SUBDIVISION COMMITTEE
METROPOLITAN AREA PLANNING COMMISSION

STAFF REPORT
(Final Plat)

CASE NUMBER: S/D 91-43 - FIRE STATION 16 ADDITION

VICINITY MAP:

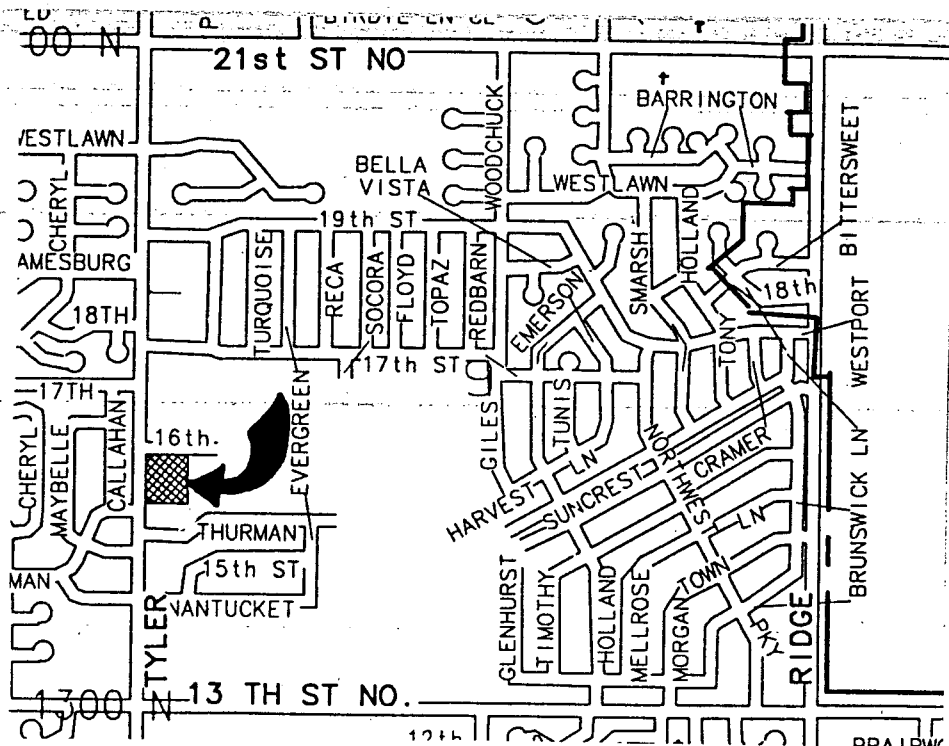
- A. The applicant shall provide for the paving of 16th Street North adjacent to the north line of the plat. The applicant shall also provide a proper turn around for Robin at the south line of the plat.

- B. On the final plat tracing, the face of the plat shall delete the word "complete" from the access control shown to Tyler Road since an opening is being provided. And since complete access control is being dedicated to Robin, the plat's text shall also note this dedication.

- C. On the final plat tracing 16th St. North and the indicated right-of-way shall be properly indicated. The position of the center line (C/L) of 16th Street North should be properly located and shown with a 32 foot half street right-of-way, or if all of the street's right-of-way is shown, the C/L should be deleted and the street name centered within the 64 foot right-of-way.
